RE: **Blythe Solar Power Project, Docket No. 09-AFC-6**
Responses to January 14, 2010 CEC Workshop Queries
Technical Areas:
Soil & Water Resources (supplemental data for DR-S&W-218)

**Soil and Water Resources
(Supplemental Data for DR-S&W-218)**

Blythe Solar Power Project
Docket No. 09-AFC-6

Soil and Water Data Responses to January 14, 2010 CEC Workshop Queries

Channel Profiles – CP-001 – CP-009

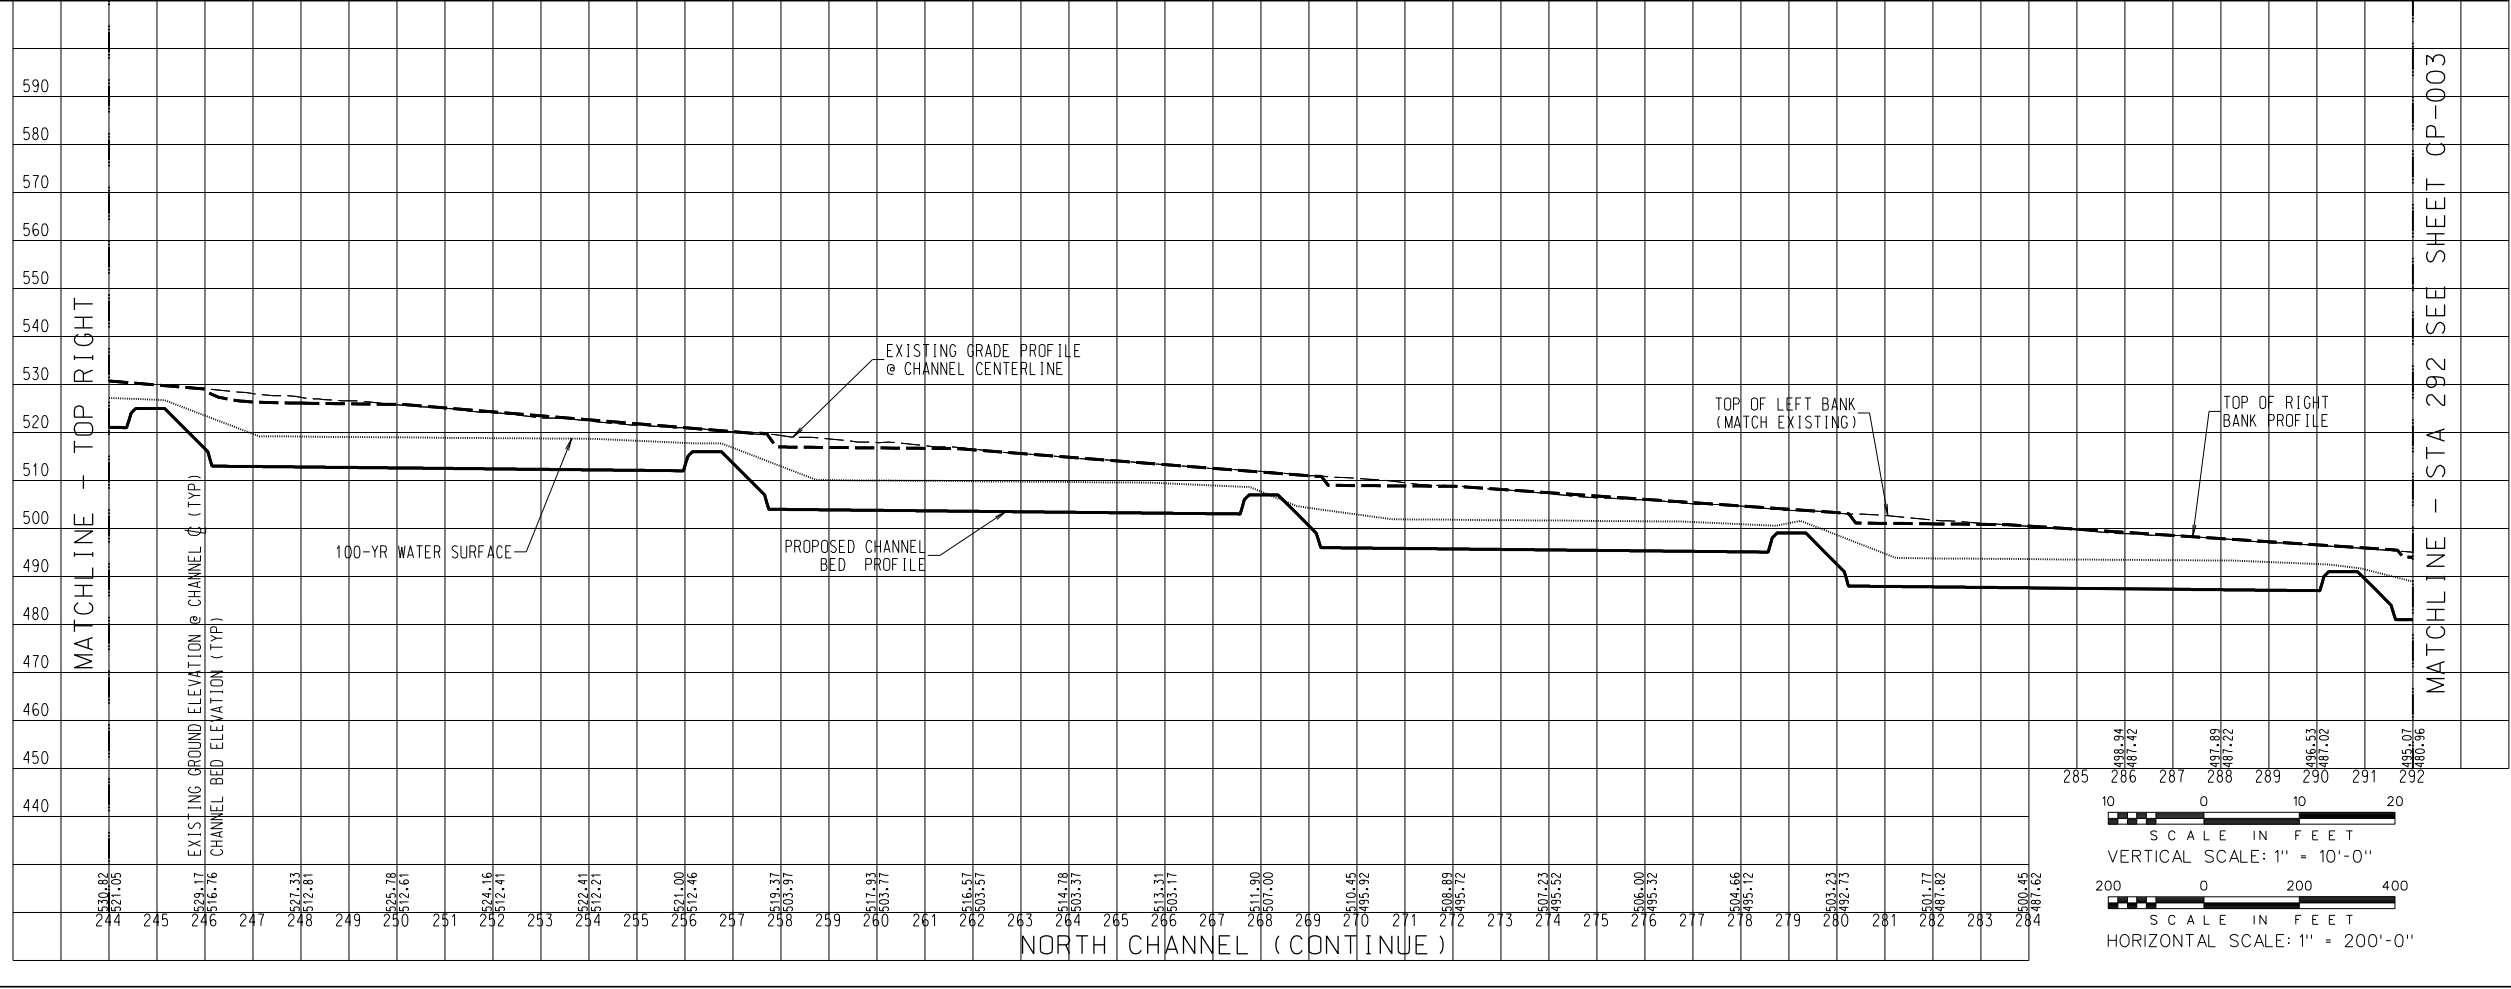
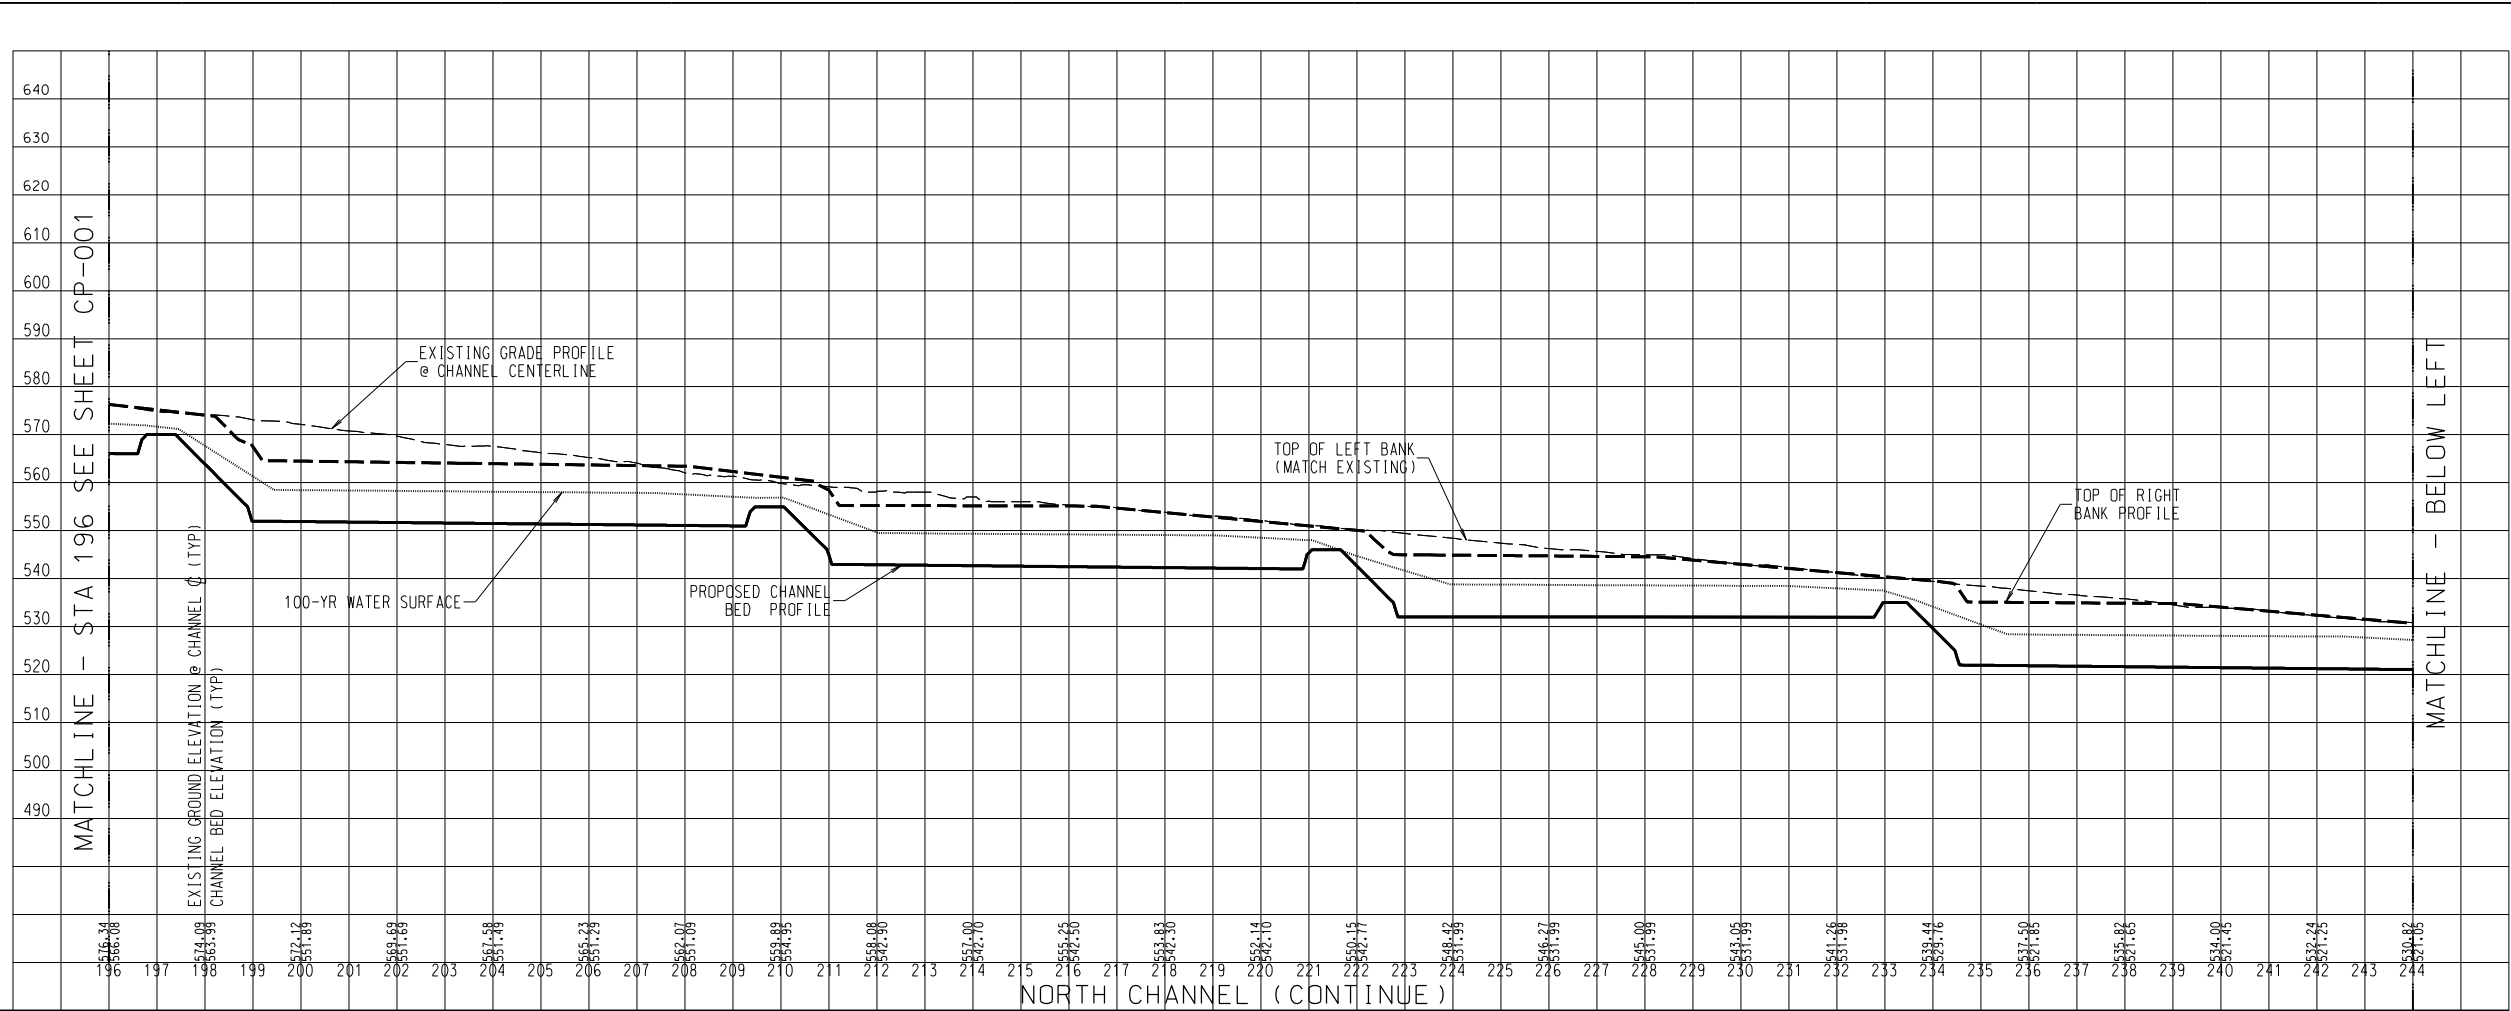
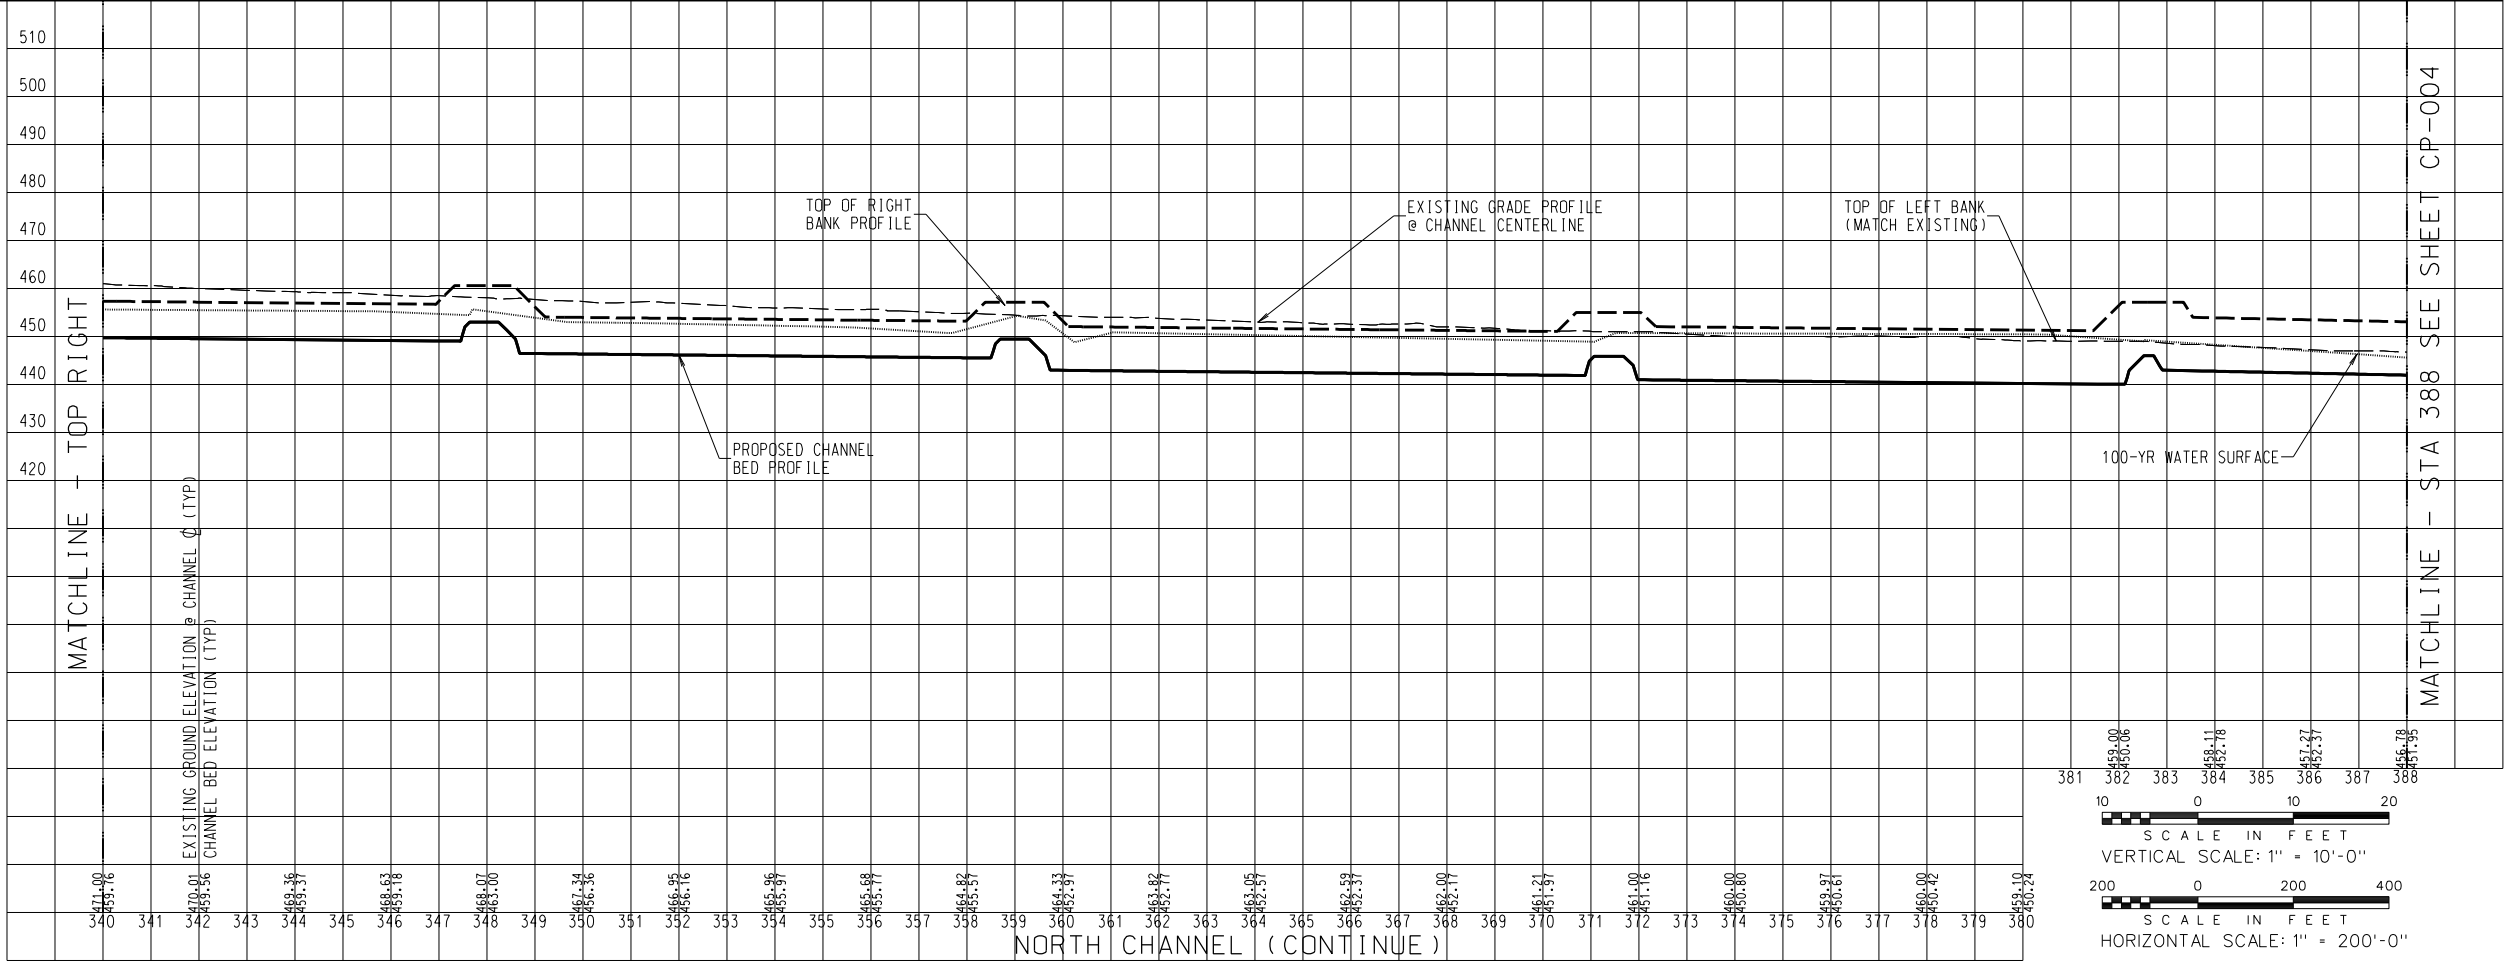
Add 100-yr. water surface elevations on profiles for main channels (both collectors and conveyance).

The 100-year water surface profile has been added to the plans and is provided on Sheets CP-001 to CP-009 as part of this response.
